THE WATERMARK

parksville bc

Re: 'Water Mark' Zoning Amendment – Lot 1 District Lot 89, Nanoose District, Plan VIP78996 (161 Island Highway West) – Planning File 3360-09-02

**SUBJECT: PLANNING REVIEW OF REVISED PARKSVILLE BEACH MOTEL REZONING SUBMISSION
RECEIVED JULY 15, 2010 ON LOT 1, DISTRICT LOT 89, NANOOSE DISTRICT, PLAN
VIP78996 (161 ISLAND HIGHWAY WEST) - OUR FILE 3360-09-02**

Figure 1 -Proposed View Corridors from Alberni Hwy & Morrison Clock Park. Original artwork by Michele Cloghesy, Urban Planner

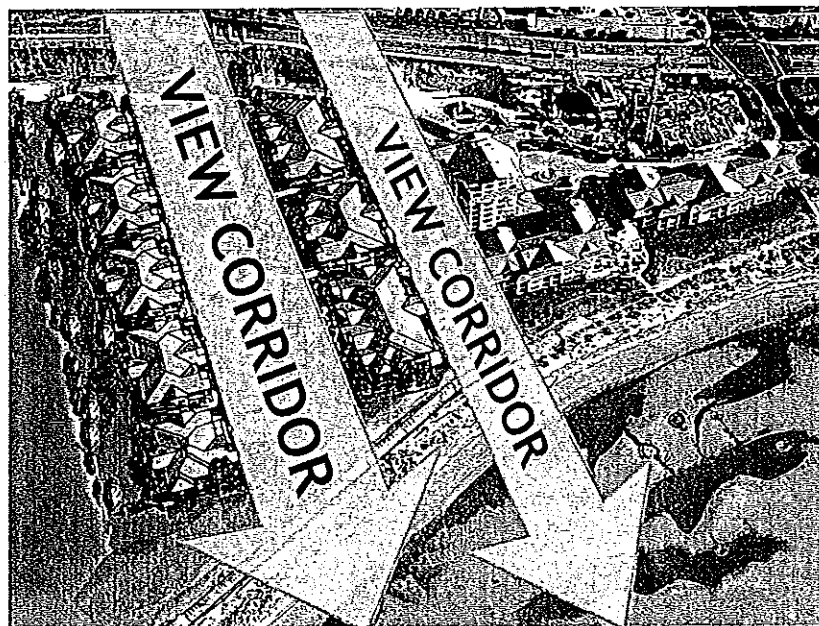
6. Two major view corridors will be retained through the site looking out to the coast mountain range (refer to Figure 1 below). The required 20m-view corridor aligned with the Alberni Highway will be retained, 6-18m of which will be dedicated to the City as a Statutory Right of Way (SRW). and Greenway Trail connection, essentially bisecting the subject property. The actual view corridor proposed from building face to building face is proposed at 58m, nearly (3) times the required width. A second view corridor free of buildings will be retained between the Beach Club Resort and 3 storey residential buildings a long the western property line, providing a sequence of views from Highway 19a (Section 4.10.2.1.6). We are not seeking height variances to recoup diminished development rights, as mentioned above (Section 4.10.2.1.6a);

Figure 2 - Proposed Land Dedications, original artwork by Michele Cloghesy, Urban Planner

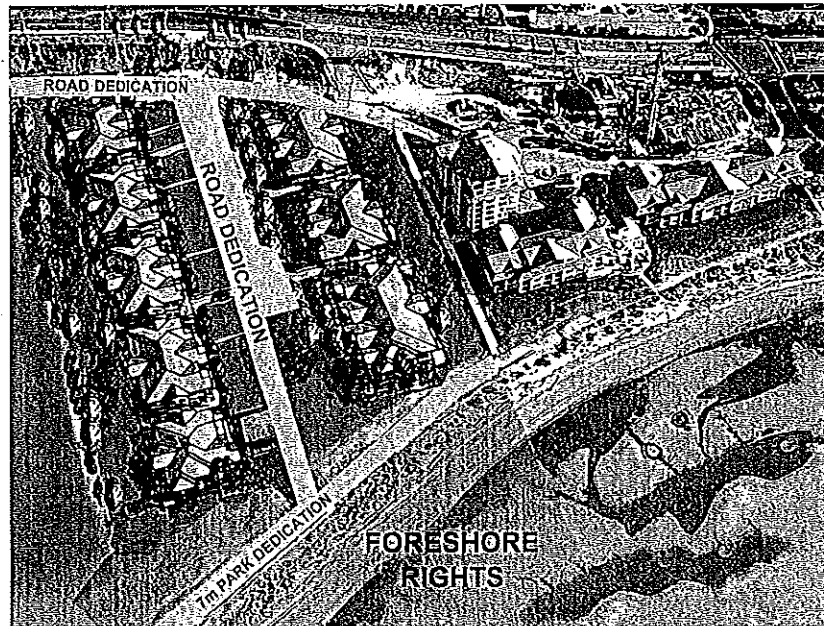
As mentioned above, a 20 m view corridor aligned with the Alberni Highway will be retained, 6-18m of which will be dedicated to the City as a SRW and Greenway Trail connection, essentially bisecting the existing property (refer to figure 2 above). This is being accommodated despite the fact that a subdivision of the property is not currently being requested (Sections 4.10.4.1, 4.10.4.2).

Figure 5 - Beachside Drive Alignment Sketch, prepared by Focus Corporation

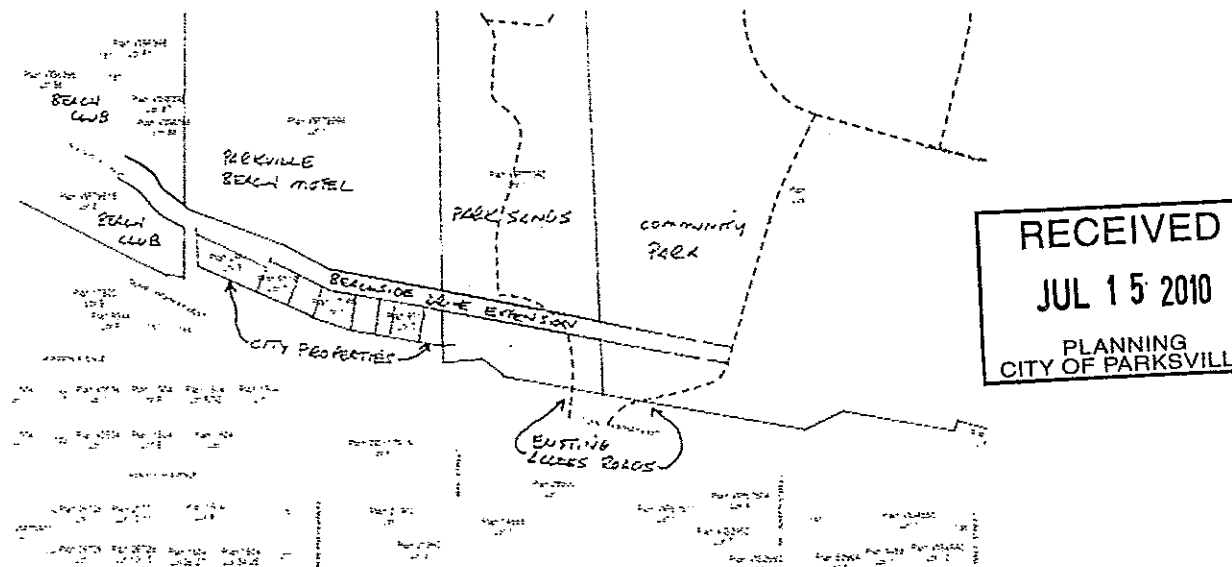
- a. The Project Engineer has developed an acceptable alignment concept through to the Community Park, which has been submitted to the Engineering Department to inform future decisions related to a Beachside Drive Connection. The Owners of the Park Sands RV Resort have not endorsed this connection. Refer to the figure below;
